SERVICE BULLETIN

N° **189-279**

REV. : A - March 1, 2022

ATA 25 - EMERGENCY LIFE-RAFT SYSTEM, ONE-TIME INSPECTION OF ACTUATION SYSTEM

Figure 1 – Incorrect installation on the RIGHT AW189ELS

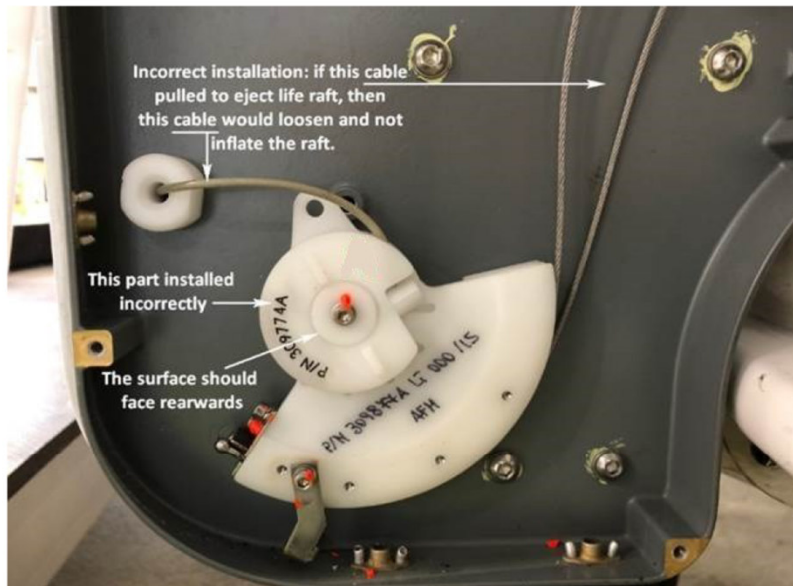
A case of incorrect installation of the raft actuation system on AW189 Emergency Liferaft System (ELS) has been reported, refer to Figure 1.

The Upper pulley P/N 309774A is a single component mounted specularly on both left-hand and right-hand ELS installations; this can lead to an incorrect installation of it and particular attention must be taken during assembly phase because its position on the Lower pulley varies for left-hand and right-hand installation. A not proper installation of the Upper pulley P/N 309774A and raft activation cable imply the incorrect functioning of the ELS in emergency condition.

- 2 Otherwise, if you see the part number on the upper pulley as, go to step (5).
- (5) In case of incorrect installation detected, refer to Service Bulletin 189-25-010 to replace the components incorrectly installed.

Figure 4 – Correct installation on LEFT AW189ELS

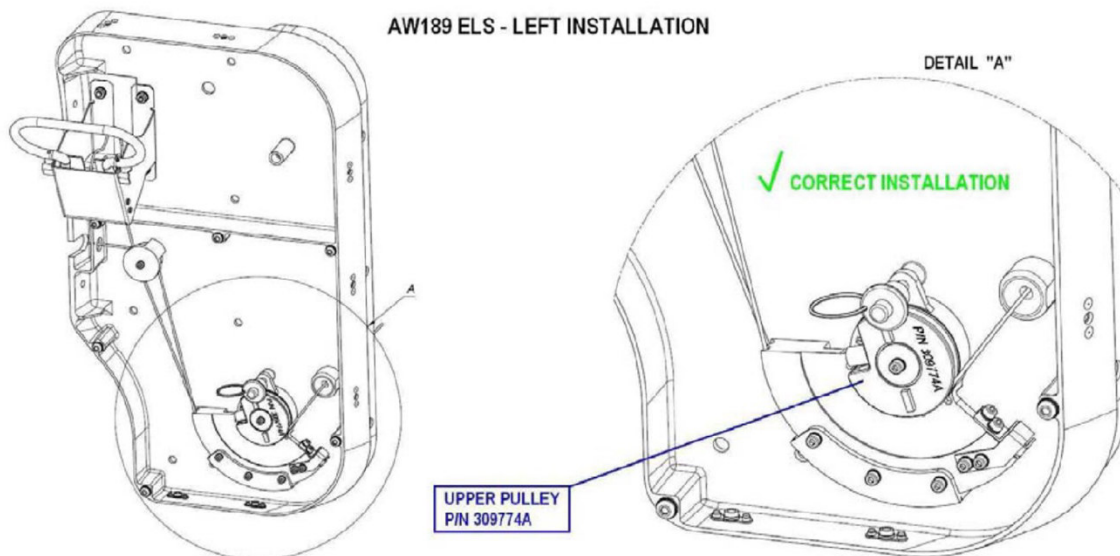
- (4) Visually inspect the installation of the raft actuation cable and the Upper pulley P/N 309774A, checking that:
 - (a) For Left Emergency Liferaft System, you must read the part number (P/N 309774A) of the Upper Pulley in case of correct installation; refer to Figure 4.
 - 1 If the raft actuation cable and the Upper pulley P/N 309774A are correctly installed as per Figure 4, skip to step (6).
 - 2 Otherwise, if you don't see the part number on the upper pulley, go to step (5).

The marked part number is showed on the Upper Pulley surface; So, the Part number is in-sight.

Figure 5 – Correct installation on RIGHT AW189ELS

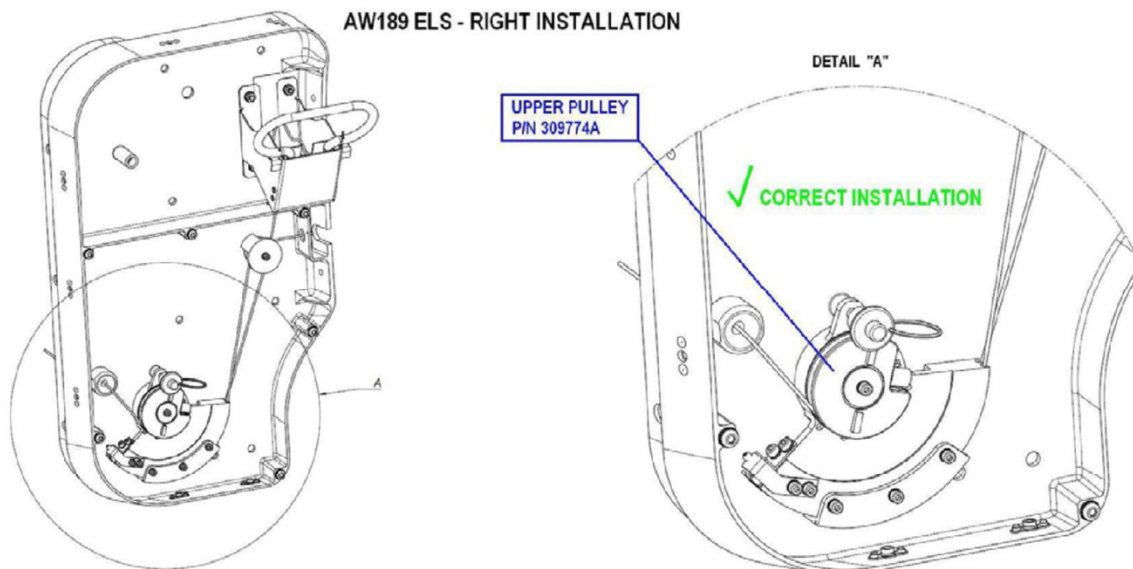
- (b) For Right Emergency Liferaft System, in case of correct installation, you cannot read the part number (P/N 309774A) of the Upper Pulley.
 - 1 If the raft actuation cable and the Upper pulley P/N 309774A are correctly installed as per Figure 5, skip to step (6).

The item part number is marked on the Upper Pulley surface mating with Lower Pulley; So, the Part number is not in-sight.
